DESCRIPTIVE REPORT

Type of Survey SHORELINE (Photogrammetric)Field No. Office No. T-13098

State WASHINGTONGeneral locality STRAIT OF JUAN DE FUCALocality DUNGENESS BAY1966-67

REVIEW REPORT T-13098
SHORELINE
September 1969

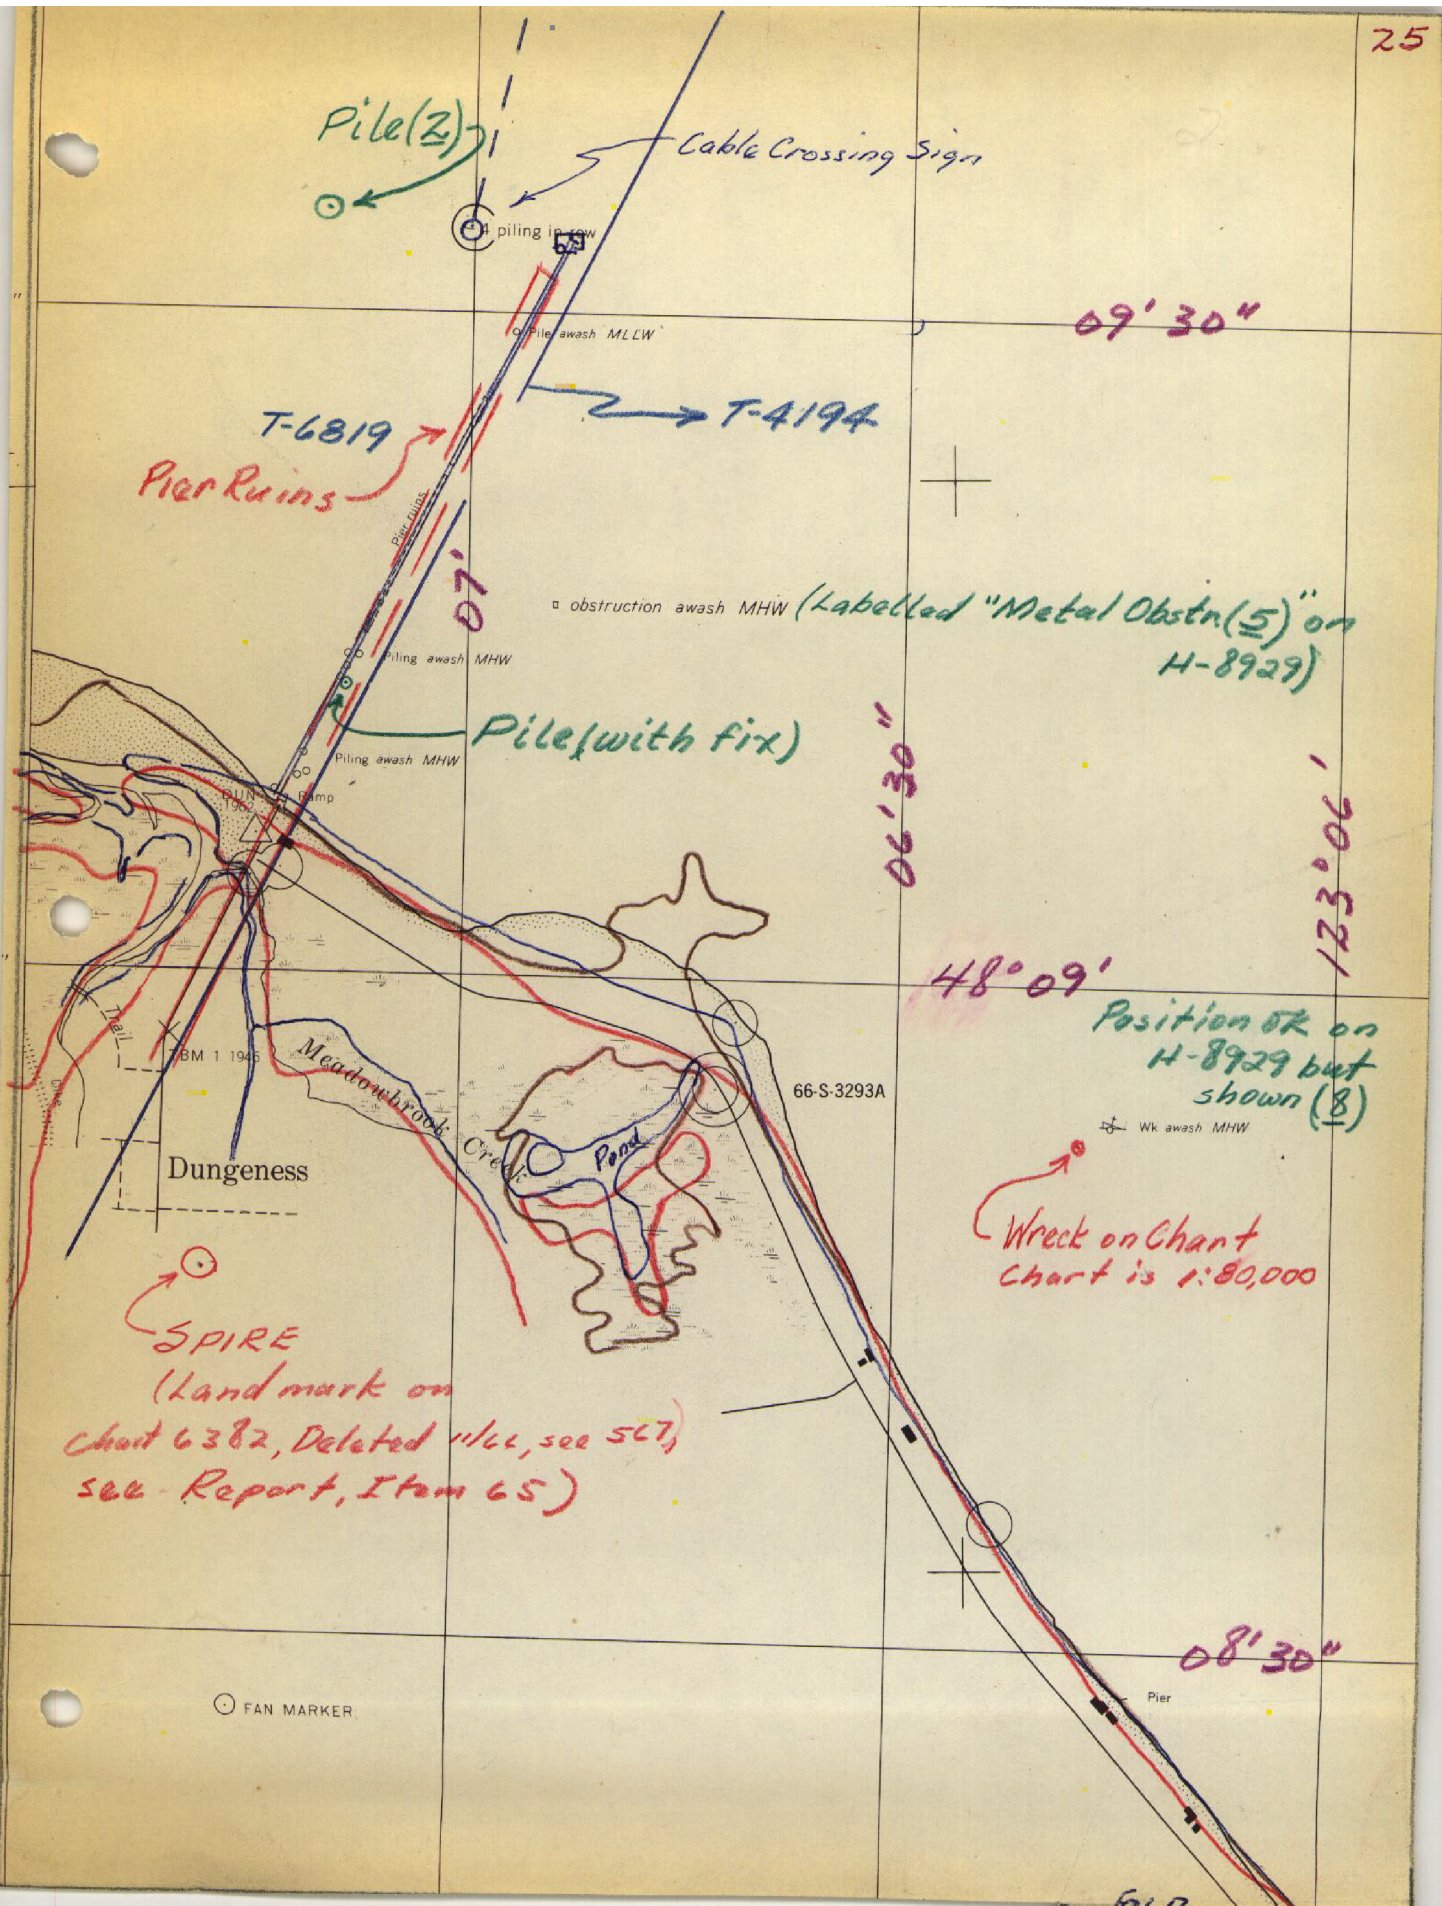
There are shoreline differences to 150 meters near $48^{\circ} 11'$, $123^{\circ} 06'$ (page 24), 125 meters near $48^{\circ} 09.2'$, $123^{\circ} 07.4'$ (page 25), and others reflecting the changing shoreline in exposed areas, see pages 24 thru 26 .

T-6819 shows two 75' radio poles near $48^{\circ} 10.93'$, $123^{\circ} 06.5'$ (page 24), that are not visible on the photographs and were not noted by either the field inspector or the field editor.

There are shoreline differences of more than 100 meters on Dungeness Spit near $48^{\circ} 09.6'$, $123^{\circ} 07.5'$ and $48^{\circ} 11'$, $123^{\circ} 06'$ (page 24); and slightly smaller differences near $48^{\circ} 09.2'$, $123^{\circ} 07.5'$, and $48^{\circ} 09'$, $123^{\circ} 06.7'$ (page 25).

H-8929 shows three features offshore that do not appear on this survey. A "deadhead" near $48^{\circ} 10.25'$, $123^{\circ} 07.4'$ (page 24); a "pile (2)" near $48^{\circ} 09.6'$, $123^{\circ} 07.2'$ (page 25); and a "pile", the 5th of a group of 4 on this survey near $48^{\circ} 09.23'$, $123^{\circ} 07.13'$ (page 25). These features were not visible on the photographs and were not noted by either the field inspector or the field editor.

The chart shows three landmarks that are not on T-13098, noted on the Comparison Print: "SPIRE" near $48^{\circ} 08.8'$,

123° 07.3' (page 25); "CUP" near 48° 07.7', 123° 05.2 (page 26); and "SPIRE" 48° 07.6', 123° 05.0' (page 26). These three landmarks were noted for deletion on a form 567 by the field inspector on November 3, 1966. On inquiry to the Hydrographic Branch of the Nautical Chart Division, it was reported that the 1966 "DELETION" form 567 had not been received by the branch. Appropriate copies of the field party's form 567 were forwarded to Rockville from the Atlantic Marine Center on September 29, 1969.

The difference in Chart 6382 scale with this survey, 1:80,000 against 1:10,000, makes shoreline and positioning of details an approximation, but there are visible differences in the shape of the shoreline of Dungeness Spit (page 24), and near 48° 09', 123° 07' (page 25).
